Product Change Notification / JAON-18YCSW720

CCB 5014.003 and 6256 Final Notice: Qualification of a new die size (1.932x1.860mm) for Die #1 of selected Microsemi LE9653AQC, LE9653AQCT, LE9643AQC, and LE9643AQCT catalog part numbers (CPN) available in 36L VQFN (4x6x1mm) package assembled at ASEM assembly site.

Pre and post change comparison

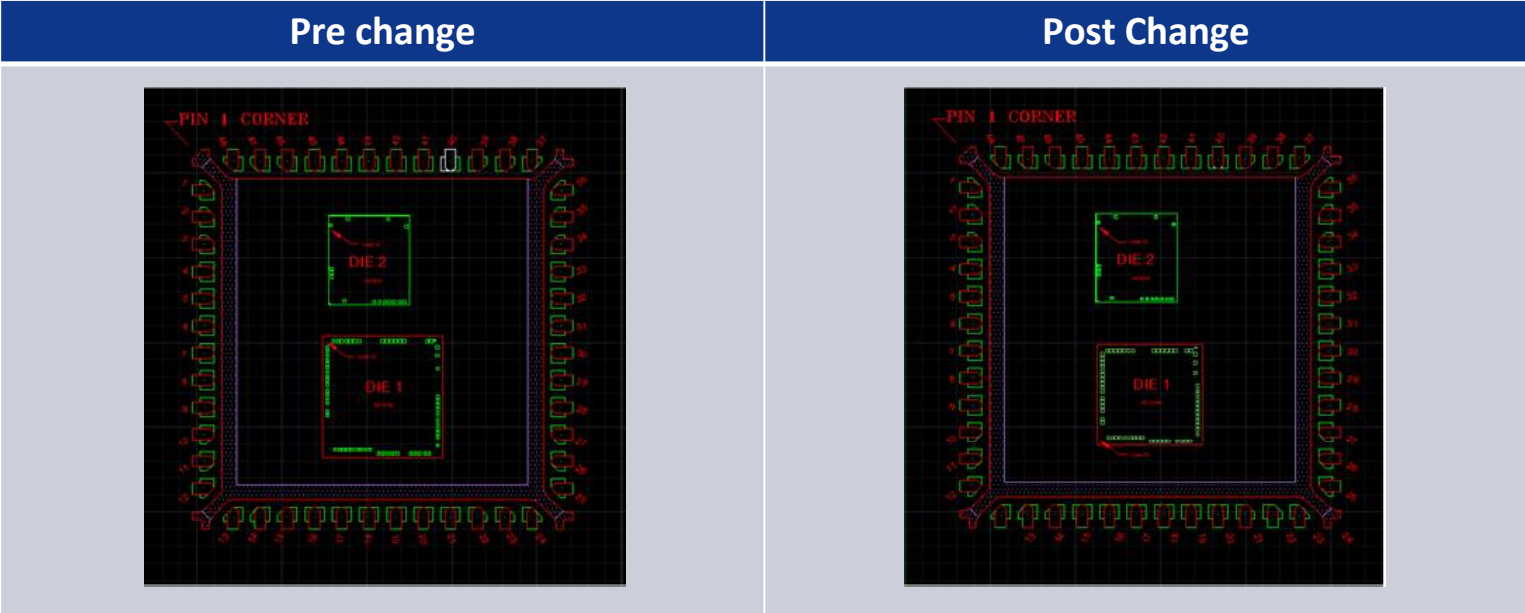
Description of Change:Qualification of a new die size (1.932x1.860mm) for Die #1 of selected Microsemi LE9653AQC, LE9653AQCT, LE9643AQC, and LE9643AQCT catalog part numbers (CPN) available in 36L VQFN (4x6x1mm) package assembled at ASEM assembly site.

| Die Size | Die # 1 | 2.204 x 2.258 mm | | 1.932x1.860mm | |
| | | Please see attached pre and post change comparison for Die # 1 Location | | | |
